Pandora Park

Summary of Findings

Prepared For: Vancouver Board of Parks & Recreation

Option A

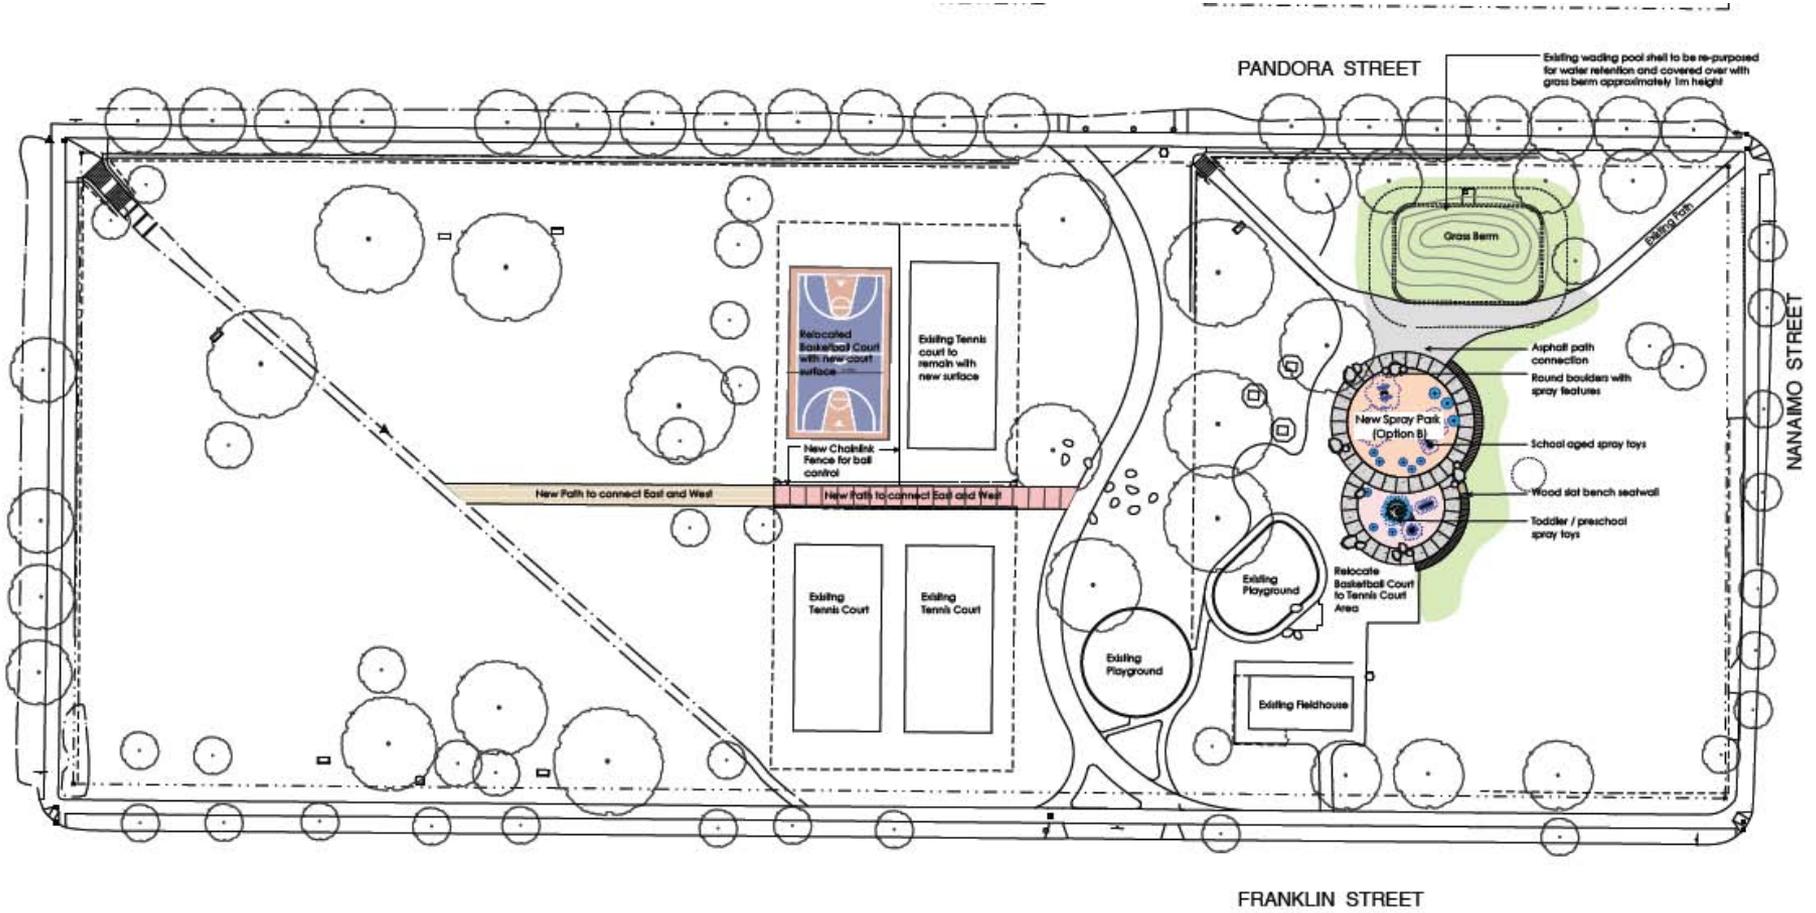
Some examples of comments provided about Option A include:

“It appears to be the less expensive and more reserved option. It would still improve the park.”

“It's pretty close to the road. I think if this option is chosen there should be some fences and gates to keep kids from accidentally running out onto Nanaimo St.”

*“Moving basketball next to tennis court will be too noisy, Too disruptive to an adult's serious tennis game.
It is not necessary to create a new path to cut across park. Probably will save on cost by not building new basketball court. “A” also retains 4 tennis courts. (How about creating a new tennis court “WALL” for solo tennis practice - so very few in Vancouver!”*

“We think option A situates the spray park too far away from the existing playground.”

“Much better than what's there now, and still always a good sunny location.”

Option A

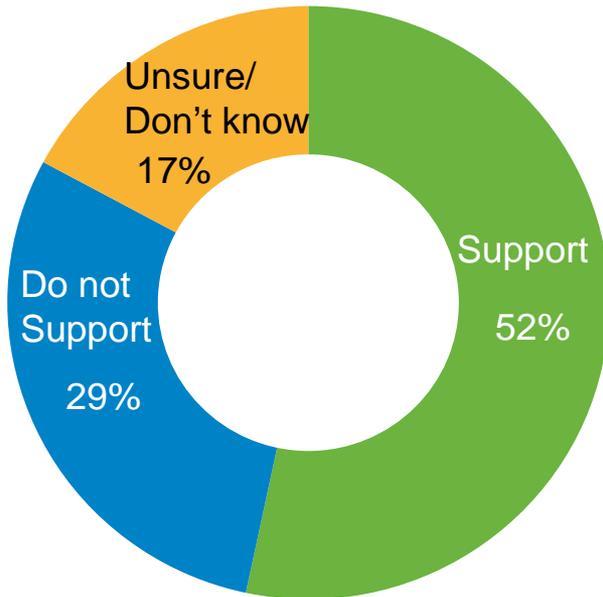
The following questions will help us to select a concept option for a children's water spray park to replace the Pandora Park wading pool. Please indicate whether or not you support [Option A] [Option B], shown below.

Option B

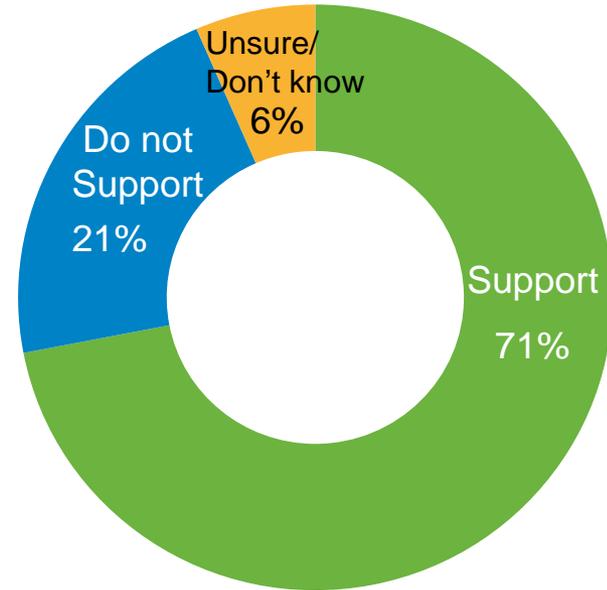
Some examples of comments provided about Option B include:

“As a parent I appreciate bringing the play clusters closer together. Easier to watch multiple children with less dashing around. And the path through the park will, I feel, make the park more united and used.”

“I like the idea of separating the basketball area from the children’s playground and spray park.”

“I think it make sense to widen the path between the courts to make it easier to walk through, but I wouldn’t extend it to the west. Keeping this green space intact would be more important than the utility of this path. Is there anything else that could be done with the old pool so that it doesn’t just get filled in? Maybe repurposed somehow.”

*“We support option B for the following reasons:
1) Close proximity to the existing playground
2) Central location (away from Pandora/Nanaimo streets and park entrance).”*

“Looks more welcoming with more pathways. I think they should look at using park for roll around park for small bikes etc.”
